# Rezoning Transportation Analysis

Petition Number: #2022-170

Date	Description
02-22-23	First Review (TM)

### 1. Curbline:

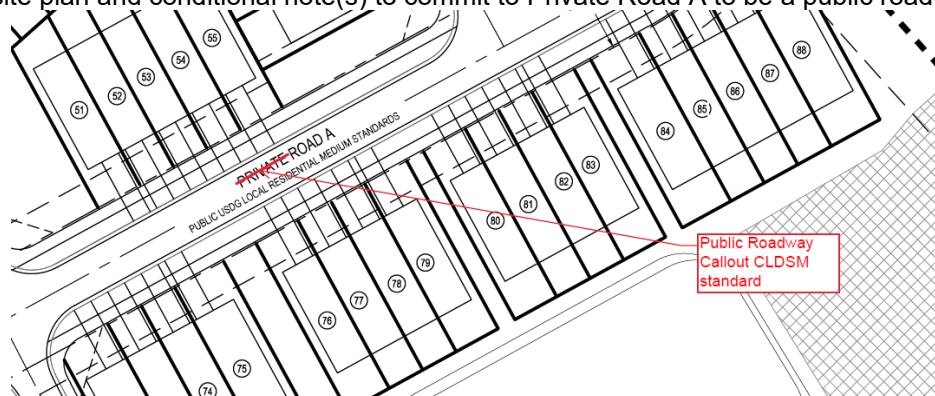
- Mt Holly-Huntersville Road:** Location of curb and gutter to be moved to 30-feet feet from roadway centerline to accommodate the Charlotte Streets Map with a roadway typical section of 4+ Avenue, Shared Use Path.
- Oakdale Drive:** Location of curb and gutter to be moved to 19-feet from the roadway centerline to accommodate the Charlotte Streets Map with a roadway typical section of 2+ Avenue, Shared Use Path.

Label and dimension the curb and gutter from the centerline for each road on the site plan.
